**TOWN OF NEWBURGH
PLANNING BOARD
TECHNICAL REVIEW COMMENTS**

PROJECT: LAKESIDE SENIOR HOUSING
PROJECT NO.: 19-22
PROJECT LOCATION: SECTION 86, BLOCK 1, LOT 39.22 & 39.23
REVIEW DATE: 27 SEPTEMBER 2019
MEETING DATE: 03 OCTOBER 2019
PROJECT REPRESENTATIVE: MAURI ARCHITECTS

MAINTENANCE SHED ELEVATIONS
MAURI ARCHITECTS PC
 73 MANSION STREET POUGHKEEPSIE NY 12601 845.452.1030 mauri-architects.com

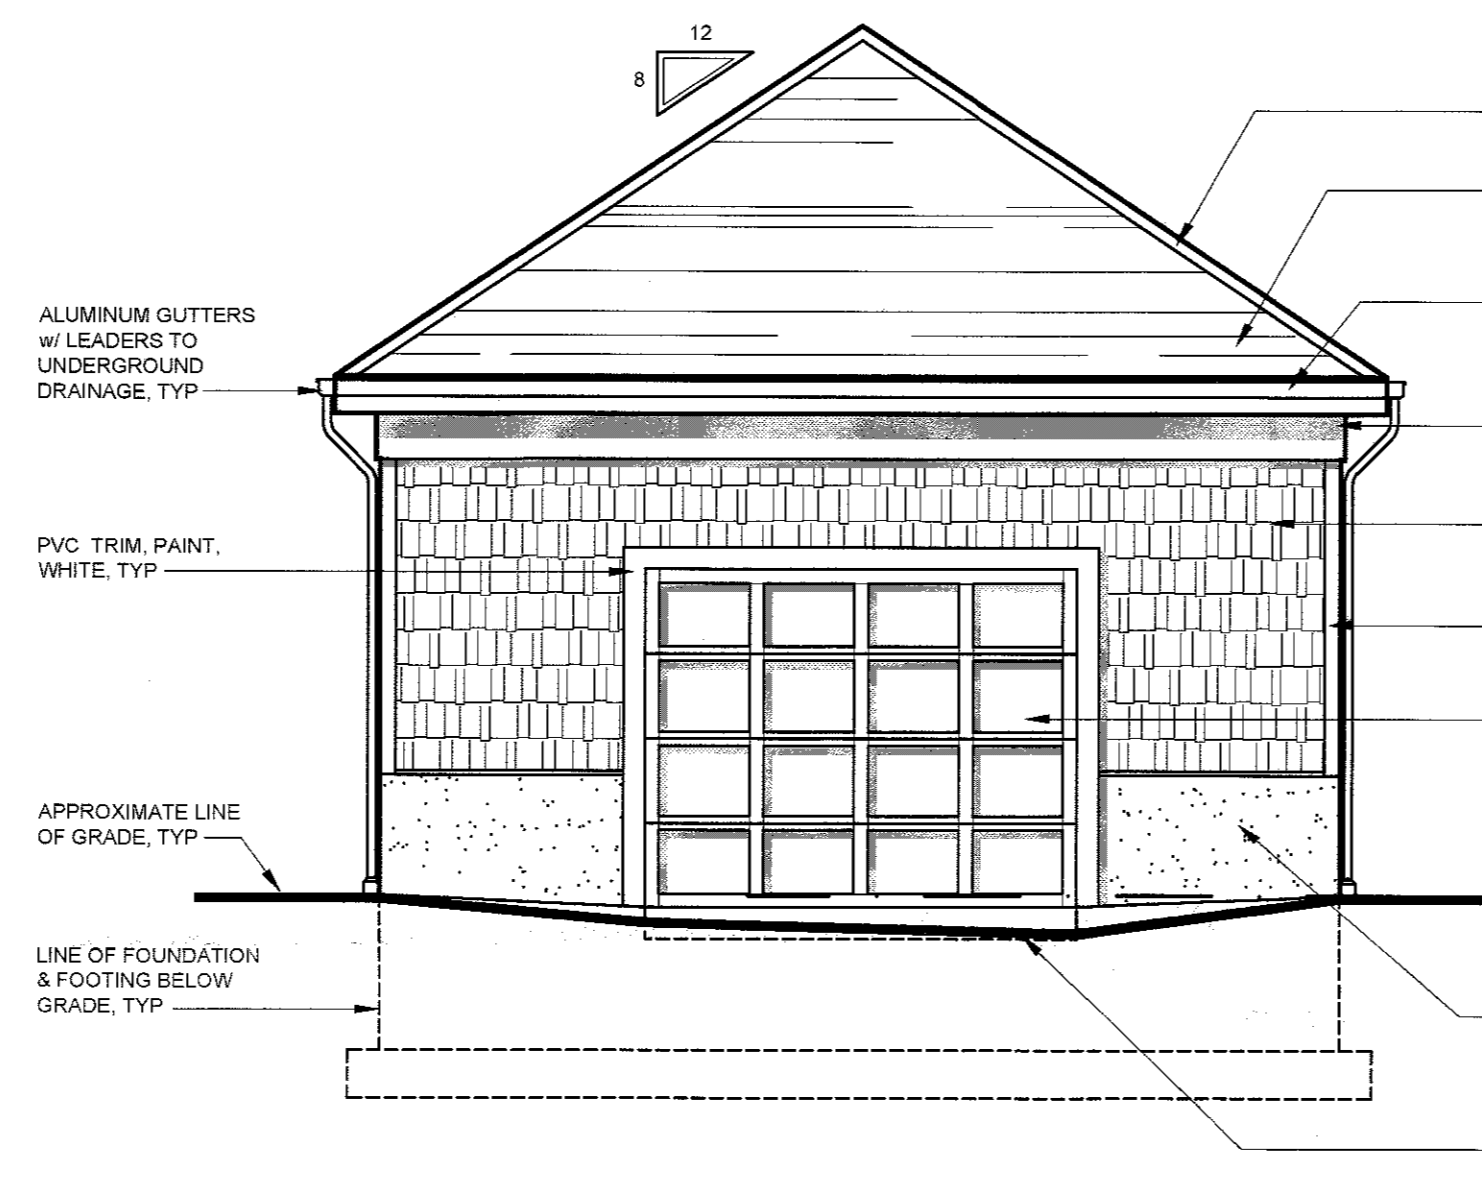
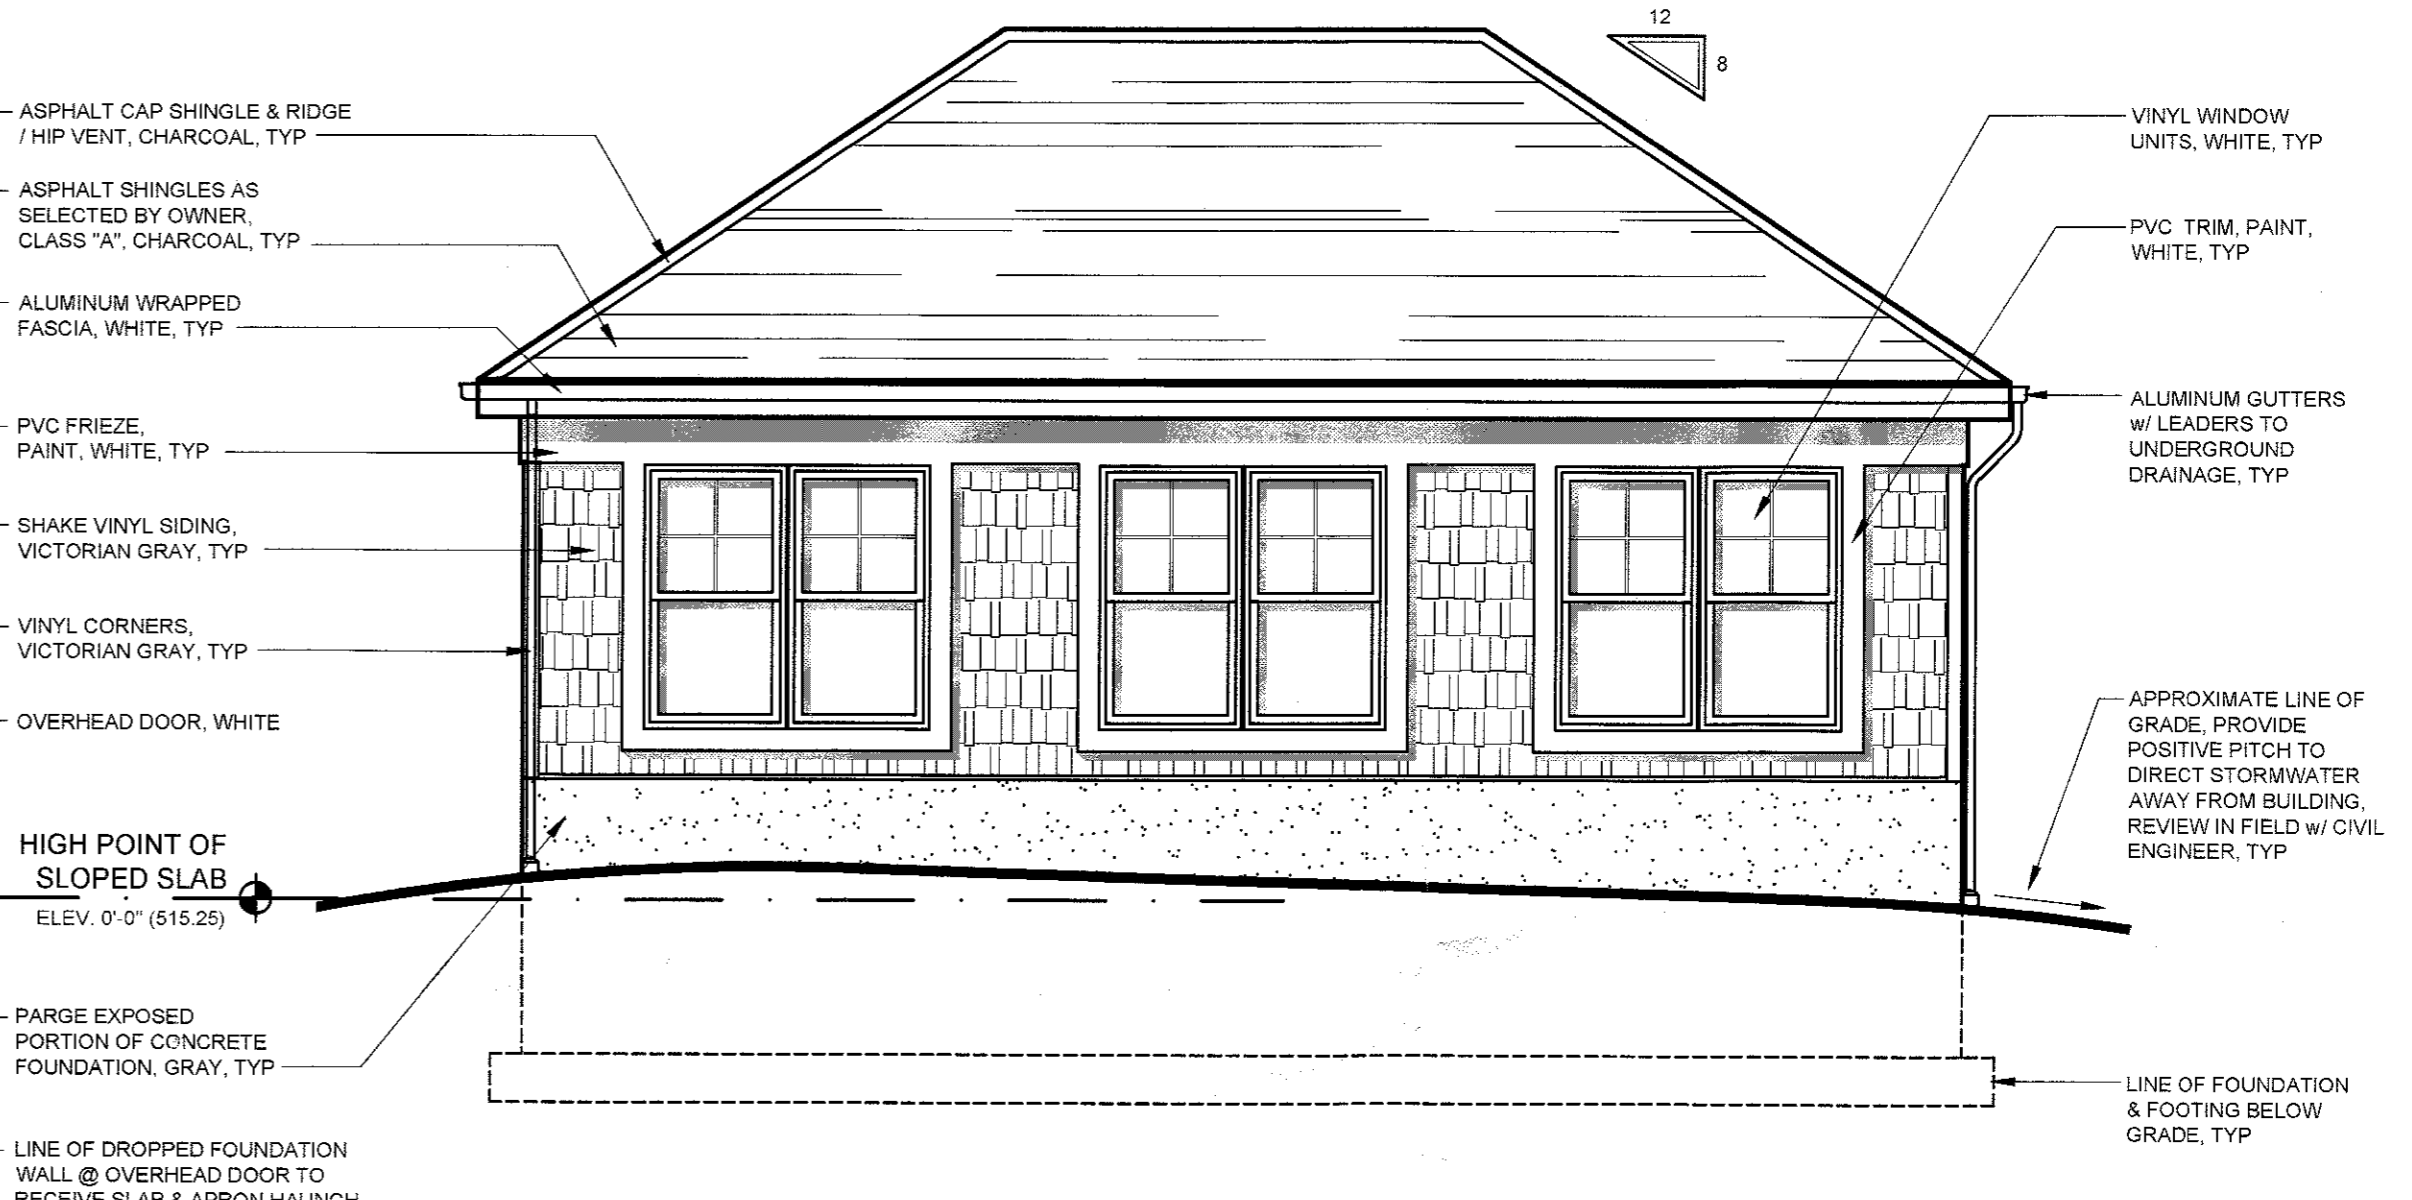
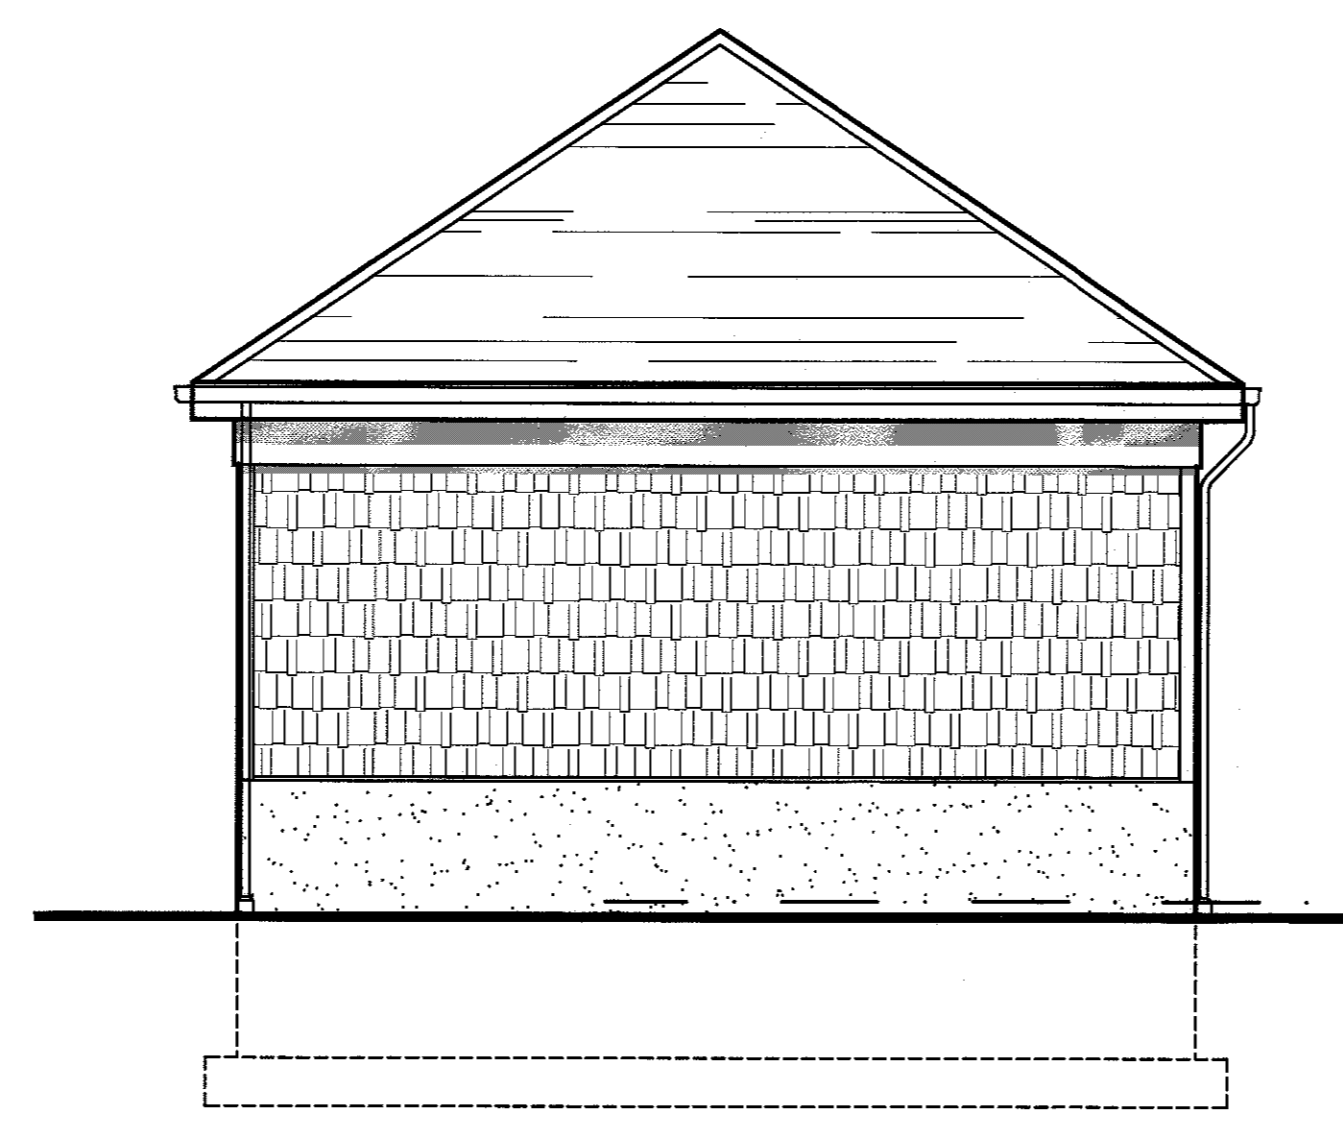
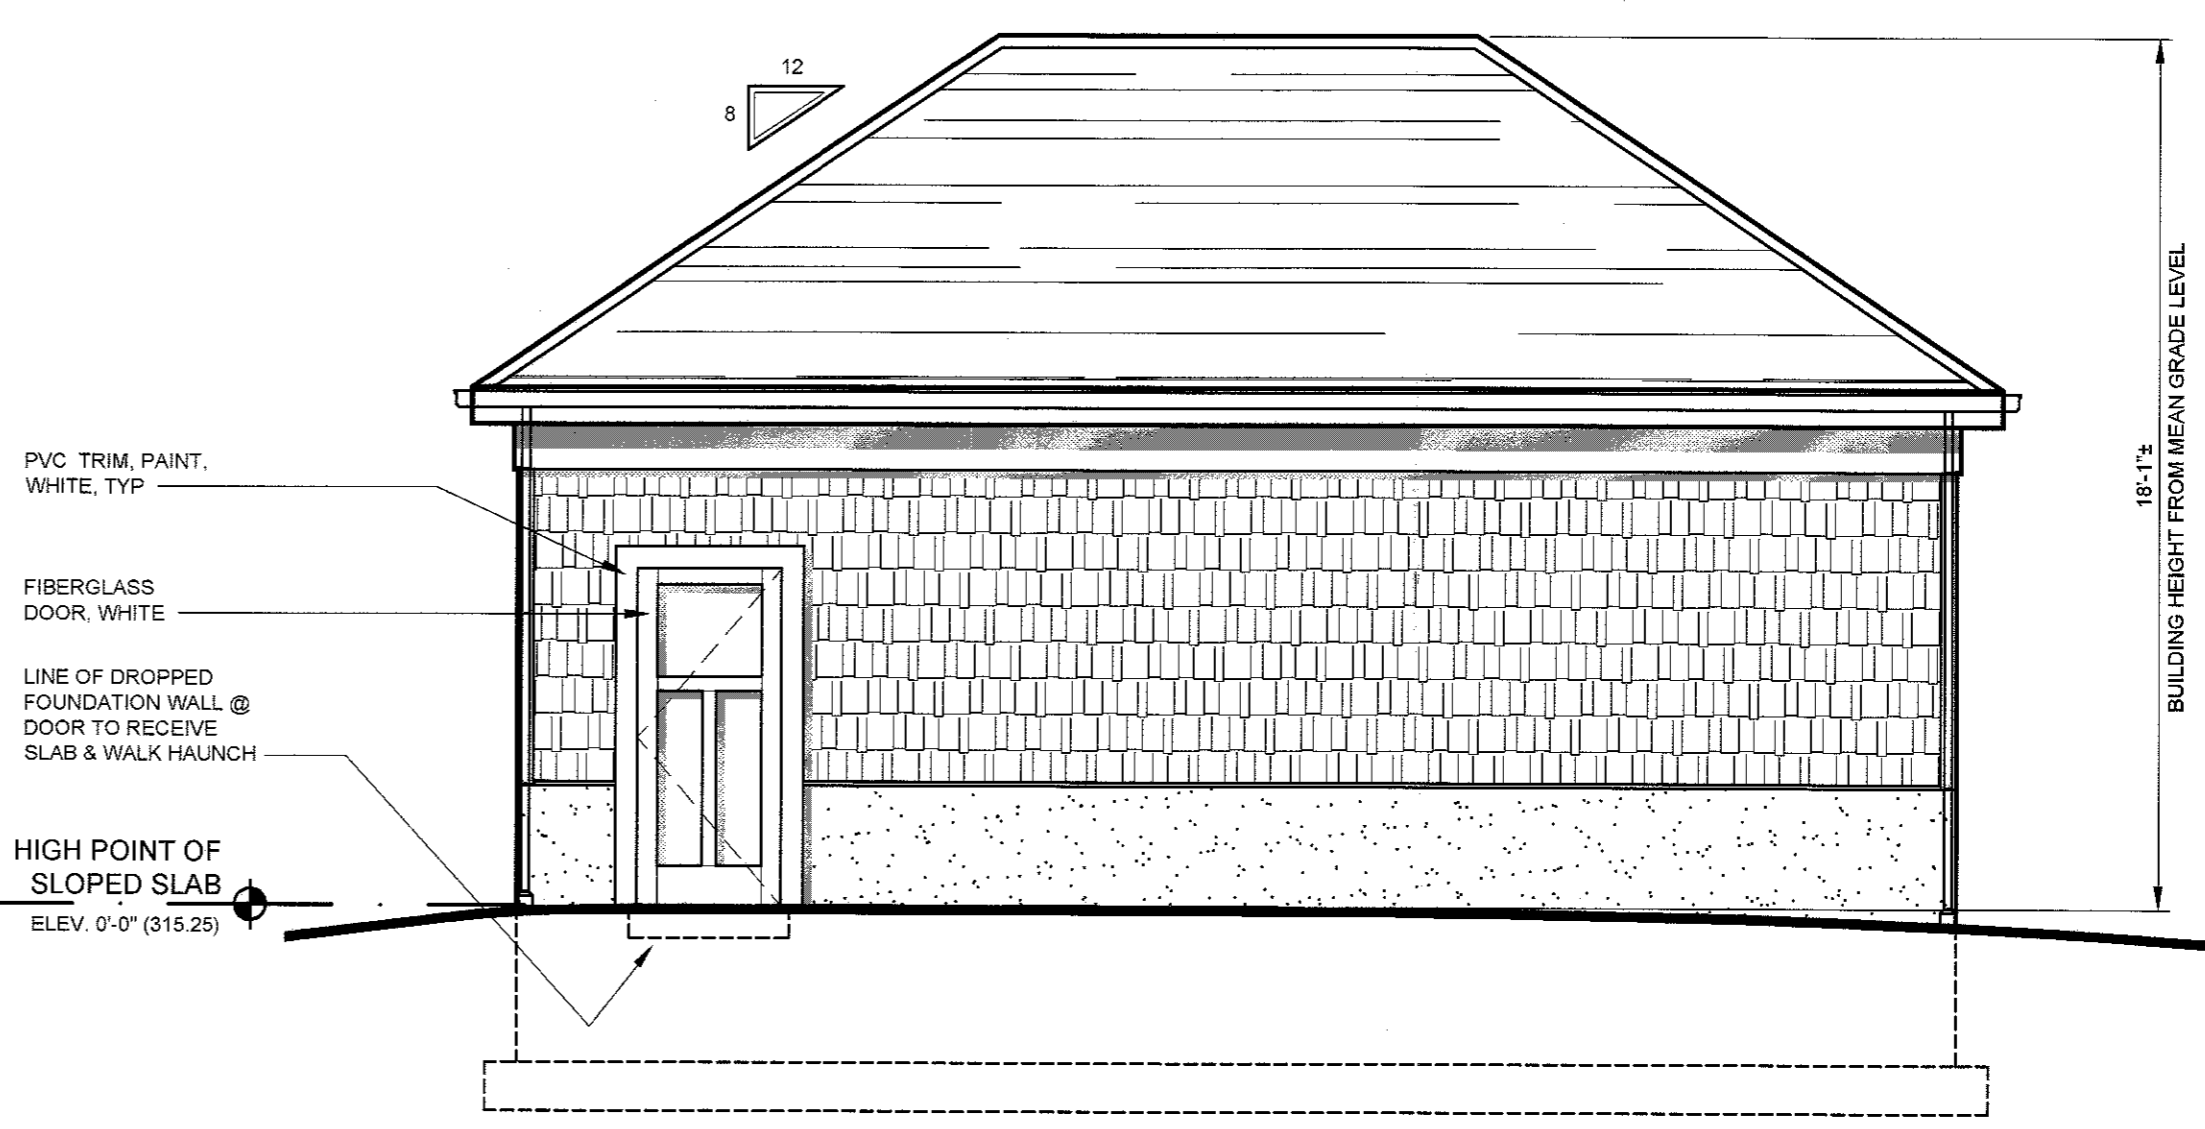
4. Architectural review of the shed is required.
5. Amended site plan approval for this project requires submission to Orange County Planning as project access road is located within 500 feet of the State Highway.
